ROCHESTER GAS AND ELECTRIC CORPORATION • 89 EAST AVENUE, ROCHESTER, N.Y. 14642

June 22, 1979

Subject: IE Bulletins 79-06A and 79-06A Revision I entitled "Review of Operational Errors and System Misalignments Identified During the Three Mile Island Incident" - additional information requested during staff review of responses R. E. Ginna Nuclear Power Plant, Unit No. 1
Docket No. 50-244

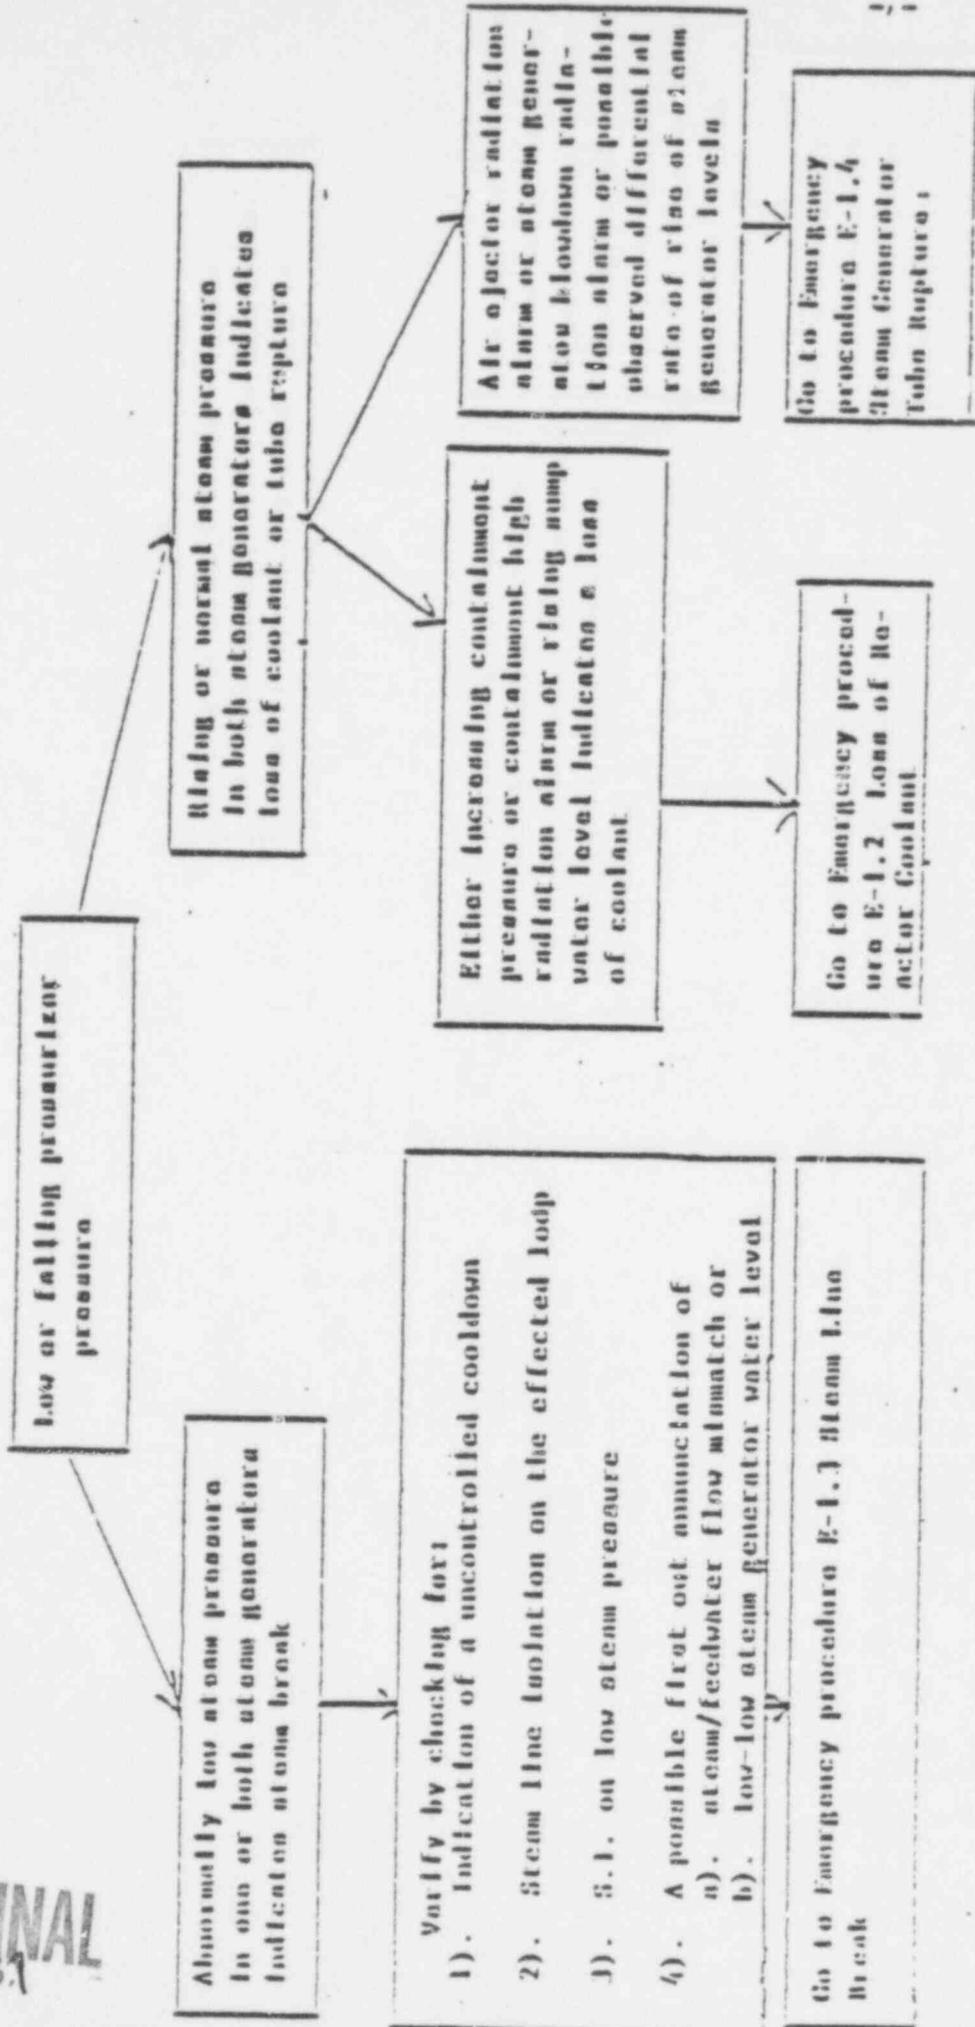
PLEASE VERIFY THAT THE IDENTIFIED PARAMETERS HAVE BEEN INCLUDED IN APPROPRIATE OPERATING PROCEDURES.

Pressurizer level has been eliminated in the diagnostic scheme for the identification of accident category. Pressurizer level has also been removed as a symptom from all RCS accident procedures except CVCS break. The operator is directed to other indications for accident identification. The diagnostic tree is attached.

The indications listed in the initial RG&E response to NRC bulletin 79-06A Rev. 1 were incorporated from the Westinghouse response to the bulletin.

- Wide range RCS temperature & pressure
- Steam pressure
- Steam generator water level
- Containment pressure
- RWST level
- Condensate storage tank level
- Pressurizer water level
- Boric acid storage tank level

All the parameters listed are not indicative of RCS water inventory. Each of these parameters except the condensate storage tank level are however, procedurally addressed in the LOCA and steam line break procedure.

The Boric acid storage tank level is addressed in LOCA and steam line break procedures in the SI pump suction change over verification to the RWST. The remaining indications listed above are symptoms of the accident, are used during the accident as operator aids for verification of safe plant conditions, are required for operator action during the accident and/or are alarmed on the control board. (The attached diagnostic tree provides an example of how the operator is instructed to consider a variety of plant indications in his evaluations).
